C0400-06
10 CFR 50.90

Donald C. Cook Nuclear Plant Units 1 and 2
LICENSE AMENDMENT FOR CHANGES IN
HIGH-ENERGY LINE BREAK METHODOLOGY

ATTACHMENT 1 TO C0400-06

DESCRIPTION OF THE PROPOSED METHODOLOGY CHANGES

Figure 1: Break Exclusion Zones
(No Longitudinal or Circumferential Breaks, No Critical Cracks, No Terminal End Breaks)
Typical for Both Units

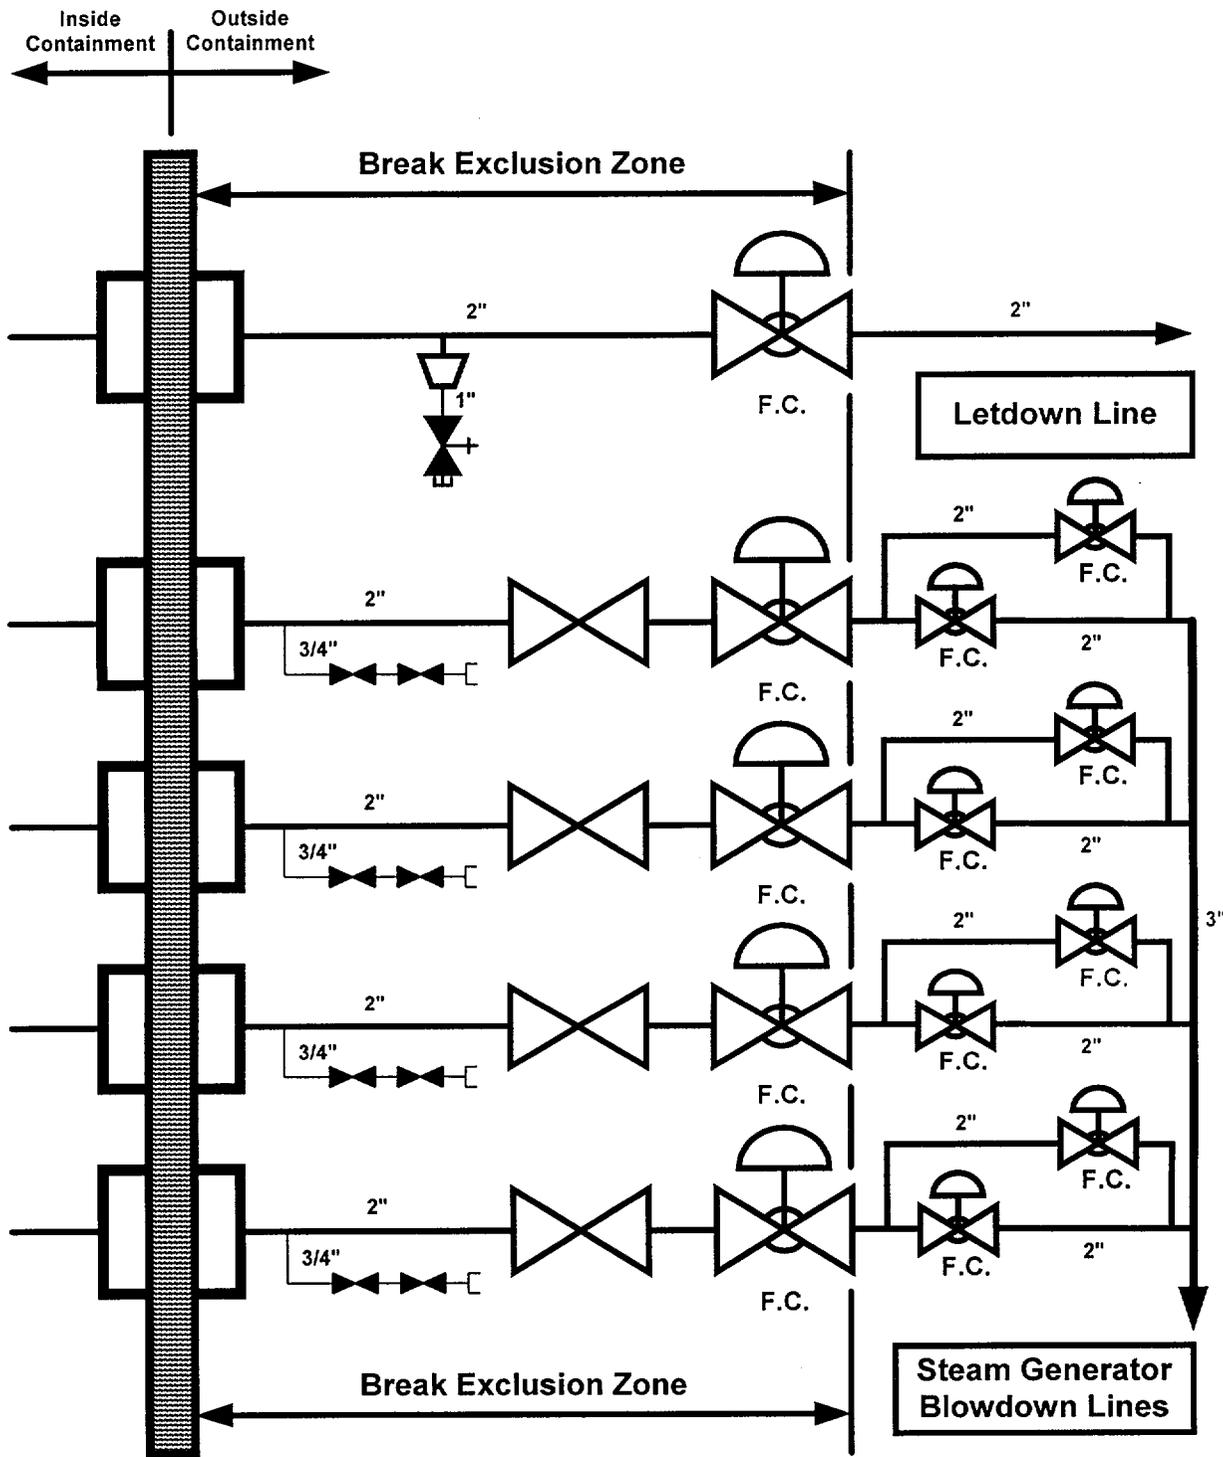
I&M proposes to apply stress analyses based on ANSI B31.1.0-1967 for use with SRP 3.6.2, BTP MEB 3-1, Section B.1.b, to establish break exclusion zones. The application of SRP break exclusion zones is requested for the SGBD and CVCS letdown lines outside containment based on piping support modifications and revised stress analyses (see Figure 1). The SRP 3.6.2, BTP MEB 3-1, Section B.1.b, provides for an exemption from break and crack considerations in the containment penetration area for piping exiting penetrations up to the first isolation valve when piping stresses are within specified limits and where the piping cannot be adversely impacted by breaks or cracks in other parts of the piping. This modifies the CNP licensing and design basis to preclude the consideration of breaks and cracks in the SGBD and CVCS letdown lines based on acceptable piping analysis in accordance with ANSI B31.1.0-1967, "USA Standard Code for Pressure Piping, Power Piping," the design code of record. This break exclusion is incorporated into the plant by modification of piping supports to ensure that the piping stresses are below the

The use of the break exclusion zones allowed by the SRP on the SGBD and CVCS letdown lines will provide the necessary reasonable assurance for protection from HELB events and incorporates the increased understanding of HELB mechanisms as addressed in the current regulatory guidance. As part of Generic Letter 87-11, "Relaxation in Arbitrary Intermediate Pipe Rupture Requirements," the NRC issued a revision to SRP Section 3.6.2, and its associated Branch Technical Position, MEB 3-1. The updates to the SRP were provided to incorporate lessons learned from operating experience and to achieve consistency with current practices. MEB 3-1, Section B.1.b, states that "[b]reaks and cracks need not be postulated in those portions of piping from [the] containment wall to and including the inboard or outboard isolation valves..." provided that the piping meets specific requirements.

The proposed changes to incorporate SRP break exclusion zones permit a relaxation of the requirement to postulate breaks and cracks in the piping from the containment wall to and including the outboard isolation valves for the SGBD and CVCS letdown lines. The SGBD and CVCS letdown piping has been analyzed in accordance with ANSI B31.1.0-1967, and support modifications have been performed to ensure that the piping stresses are below the SRP threshold for break exclusion. This analysis maintained the use of the Giambusso break stress threshold of $0.8(S_h + S_a)$, which is more conservative than the SRP threshold of $0.8(1.8S_h + S_a)$. The S_h and S_a

are allowable stresses at maximum (hot) temperature and allowable stress range for thermal expansion, respectively. The use of this approach to account for the differences between the ASME Code stress methodology used in the SRP and the ANSI B31.1.0-1967 stress methodology has been reviewed and approved by the NRC for use on ANSI B31.1.0-1967 piping located inside containment at Crystal River Unit 3 by letter dated September 28, 1989. Also, the effects of breaks outside of the break exclusion zones have been reviewed and determined to not have an adverse impact on the piping within the exclusion zone. The use of this methodology and the modification of the supports ensure sufficient margin to preclude breaks and cracks in this region of piping.

Figure 2: Steam Generator Blowdown Line Crack Exclusion Zone
(No Critical Cracks)
Specific to Unit 2, Unit 1 Similar

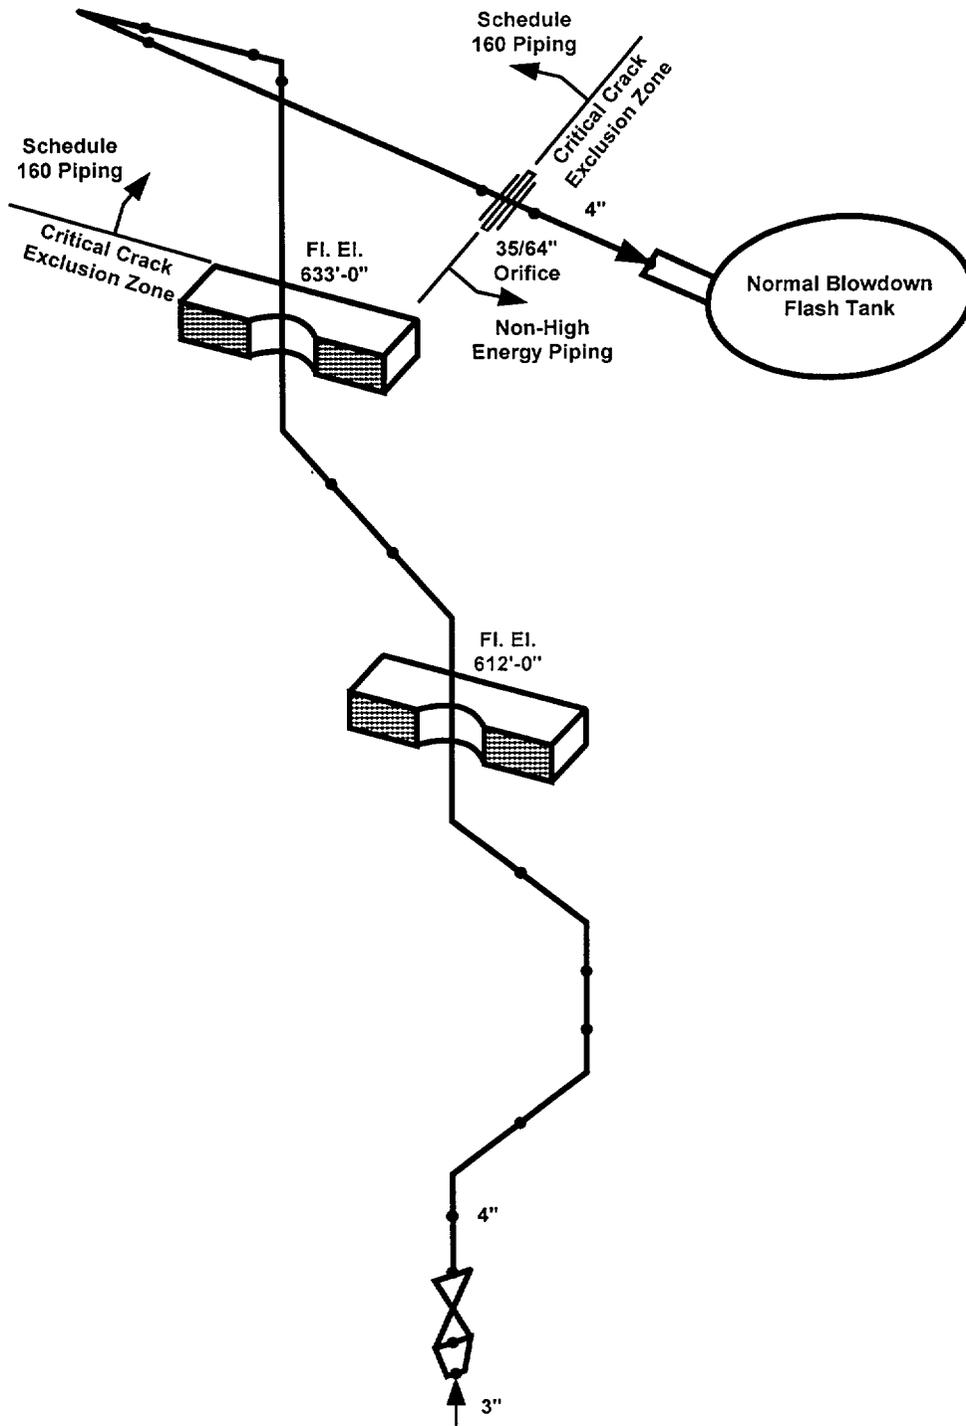
I&M proposes to apply stress analyses based on ANSI B31.1.0-1967 for use with the SRP 3.6.2, BTP MEB 3-1, Section B.1.e, methodology to a section of piping for the postulation of critical crack locations based on piping stress for a portion of Unit 2 SGBD piping located in the normal flash tank room (see Figure 2). The SRP methodology is used to eliminate postulation of a crack in this location based on acceptable stress analysis. This modifies the CNP licensing and design basis for this portion of piping to base the postulation of cracks on piping stress analysis. This crack exclusion is incorporated into the plant by replacing approximately 10 feet of piping with heavy wall piping and piping support modifications. These modifications were determined to be required by the detailed stress analyses to bring the piping stress into compliance with the regulatory guidance for crack exclusion. Unit 1 may require similar modifications and application of the SRP methodology for a crack exclusion zone. Further analysis is required to make this determination. I&M requests approval to use the SRP crack exclusion for Unit 1, if necessary.

The use of the SRP BTP MEB 3-1, Section B.1.e, methodology for postulation of crack locations based on piping stress analysis permits a relaxation of the Giambusso requirement to postulate a critical crack in the most adverse location. The SRP methodology allows postulation of crack locations based on piping stresses alone. Consistent with the methodology reviewed and approved by the NRC for Crystal River Unit 3, the crack threshold used in the stress analysis was one-half of the Giambusso criteria ($0.4(S_h + S_a)$), which is more conservative than the SRP threshold of $0.4(1.8S_h + S_a)$. This approach accounts for the differences between the ASME Code calculations per the SRP and ANSI B31.1.0-1967 calculations. This crack exclusion is being sought for a single case. The piping is a portion of the Unit 2 SGBD piping located in the normal flash tank room. Currently, a critical crack in this piping could adversely impact the N-Train batteries, which are located in the same room.

The use of piping stresses to predict crack formation is acceptable based on the SRP methodology. The stress analysis methods and the allowable stresses for exclusion of crack formation are conservative in nature and provide margin to failure, which is inherent in the material properties and allowables. The replacement of the normal piping with heavy wall piping in this area, piping support modifications, and reanalysis in accordance with ANSI B31.1.0-1967 ensures sufficient stress margin for compliance with the regulatory guidance for crack postulation. Therefore, the use of this method in this instance provides adequate assurance that the "N-Train" equipment is protected from the harsh effects of a critical crack in this piping. Unit 1 may require similar modifications and application of the SRP methodology for a crack exclusion zone. Further analysis is required to make this determination.
